No. EL/3.1.35/2 Electrical

# MODIFICATION SHEET NO. RDSO/2012/EL/MS/0419,Rev.'0' Date 20.12.12

Modification sheet to provide rubber sealing gasket in master controller of three phase locomotives.

Fig.1

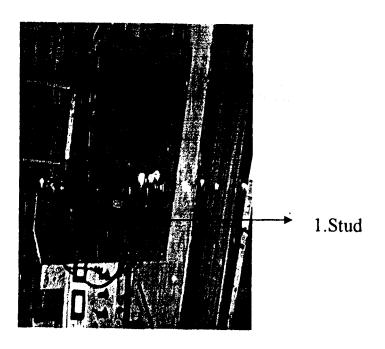
- Modified Arrangement to replace existing arrangement as given 4.0 above in 3.0:
- In order to provide rubber sealing gasket, the metal plate indicating TE/BE 4.1 position is required to be taken out which can be done by removing

spherical ball and drive direction selector and then unscrewing four screws as shown in Fig.1 of Annexure-1. After removing the metal plate indication TE/BE position, the stud of drive direction selector shall look as shown in Fig. 2.

Fig.2

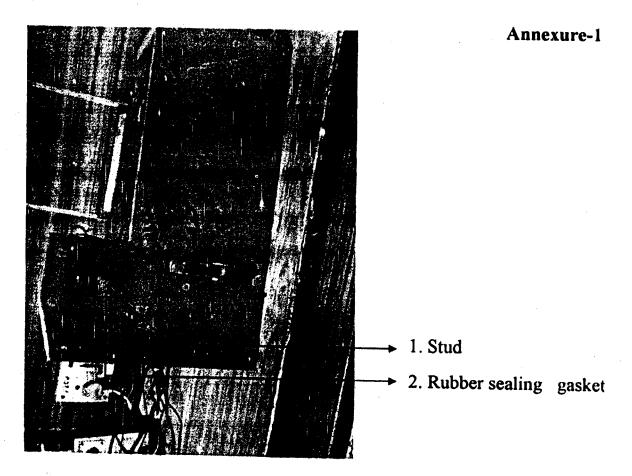
There is no rubber sealing gasket provided in the stud of drive direction selector as indicated in Fig.2 of Annexure-1.

- 4.2 Insert 30 X 30 mm<sup>2</sup> rubber sealing gasket (Fig.3 of Annexure-1). The sealing gasket for required size may be cut from a suitable rubber sheet of 5 mm thickness in the stud of drive direction selector as shown in Fig.4 of Annexure-1.
- 4.3 After inserting the gasket refit the metal plate indicating TE/BE position in its original place and tight four screws and refit spherical ball and drive direction selector handle.
